12 June 2024

SB Civil
C/-
Laila Alkamil
Senior Planner
Williamson Water and Land Advisory

RESPONSE TO ADDITIONAL INFORMATION REQUEST – 1618 ARARIMU ROAD, PAPAURA

Sheet Title Safe Intersection Sight Distance Approaching From West

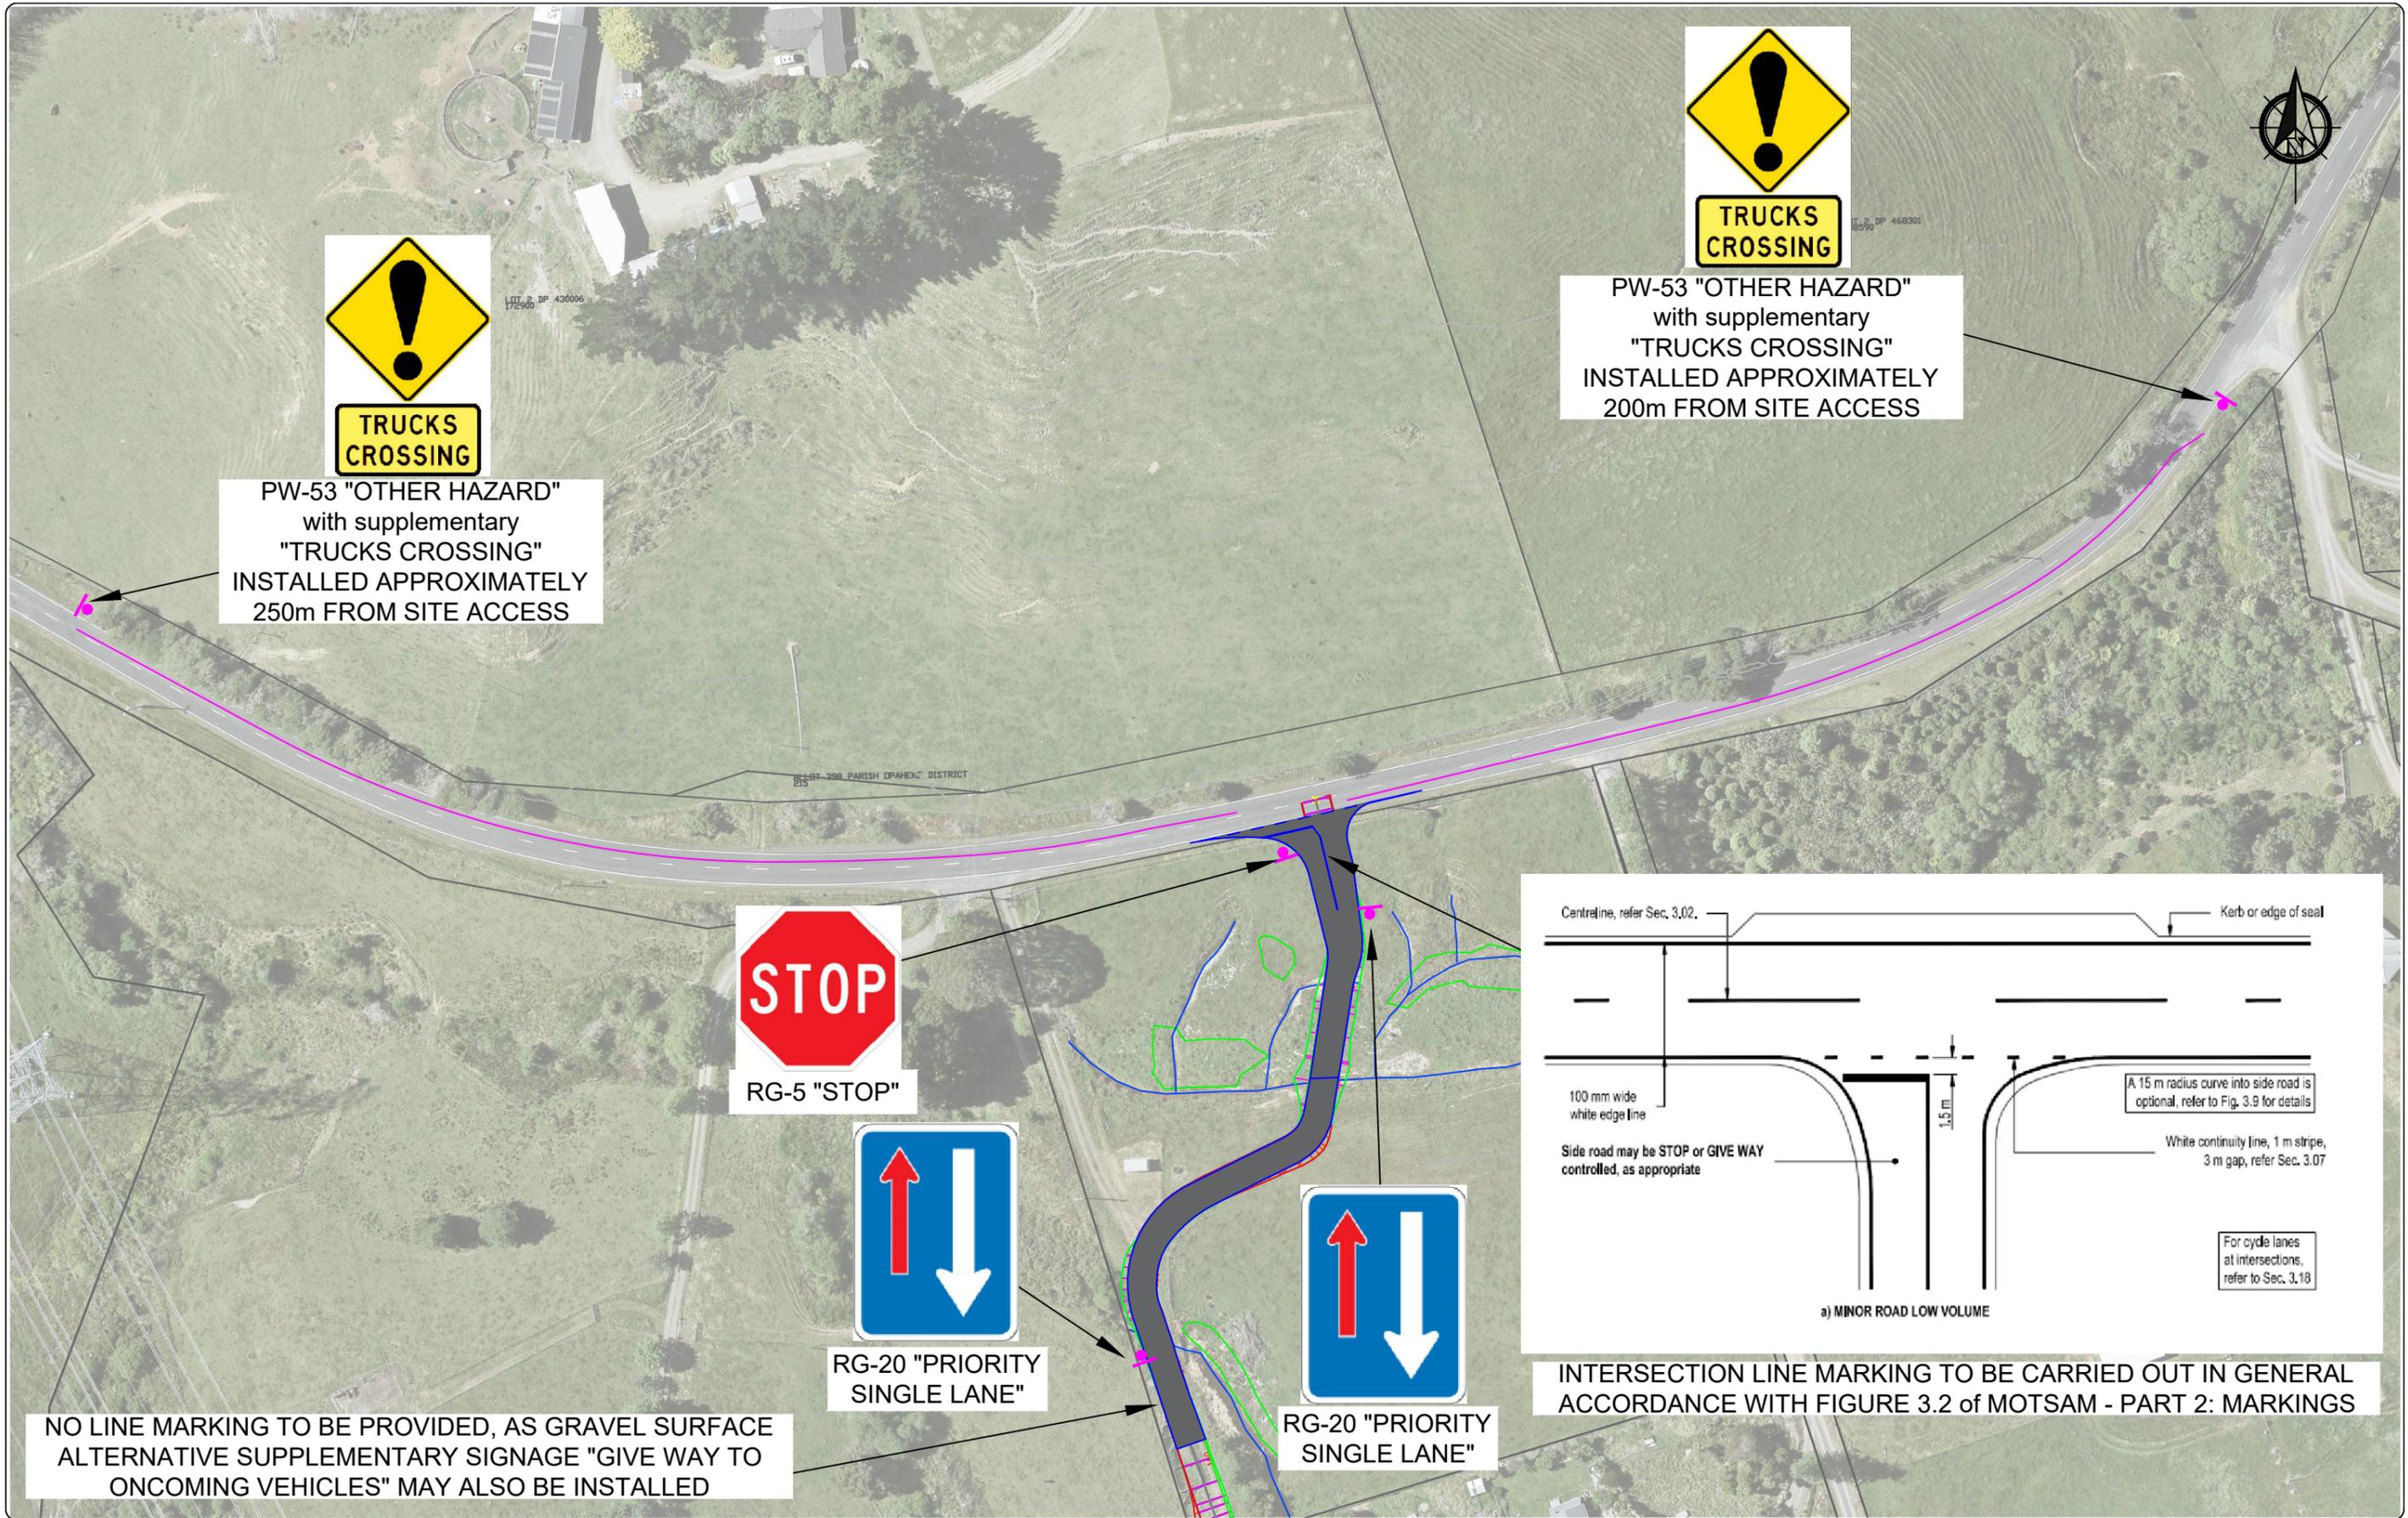
It is understood that the proposed new 23m wide vehicle crossing has been designed in accordance with AT TDM standards for a rural vehicle crossing. However, AT notes that the section of Ararimu Road adjacent to the site is identified as a low to medium collective risk, but a medium to high personal risk on the KiwiRAP road safety risk rating. Given the collective risk rating is influenced by existing low traffic volume and that the proposal would increase the truck traffic by 93% - 197% in a high operating speed environment, AT consider that consideration should be given to upgrading the crossing in accordance with the NZTA Planning Policy document to mitigate the user safety risks.

Based on additional assessment provided earlier within this information request response, providing a vehicle access for the site in accordance with NZTA PPM Diagram E is not required in order for the site access to operate safely and efficiently. Should Council agree to the proposed vehicle access arrangement, further mitigation could be considered to increase forward visibility towards the access. This will help increase the safety of the access. As such, existing scrub vegetation within the road's north berm should look to be removed, along with potential for berm regrading to open sightlines. Sightline information is provided on **Sheet 13** of the **Attachment**.

Sheet Title Concept Road Marking and Signage Plan

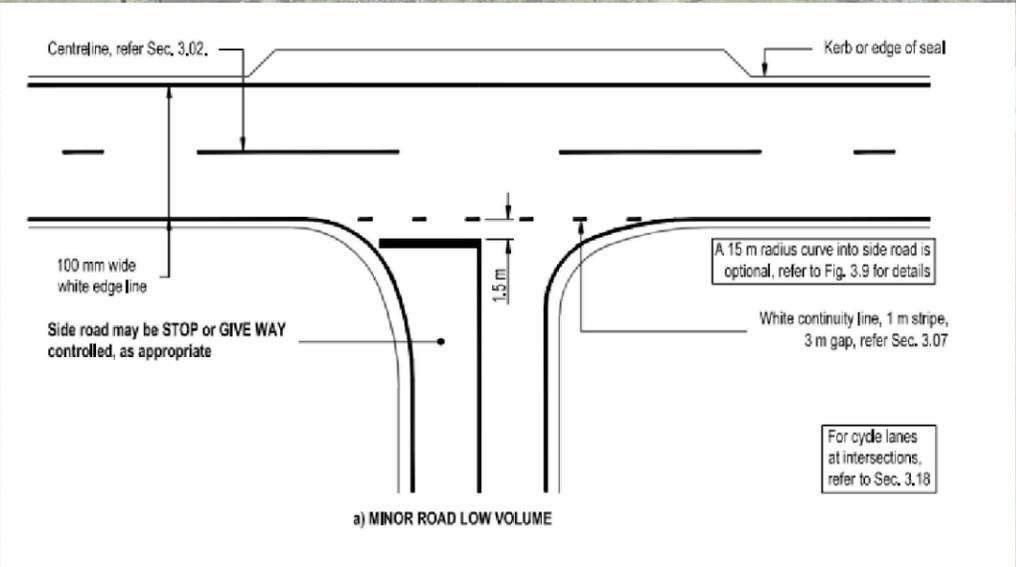
Please provide signage and markings plan annotating all traffic engineering infrastructure.

Detailed design with respect to signage and marking is anticipated to be made available post an approved Resource Consent application. A consent condition to this effect is welcomed. Preliminary signage and markings are included in **Sheet 15** of the **Attachment**.
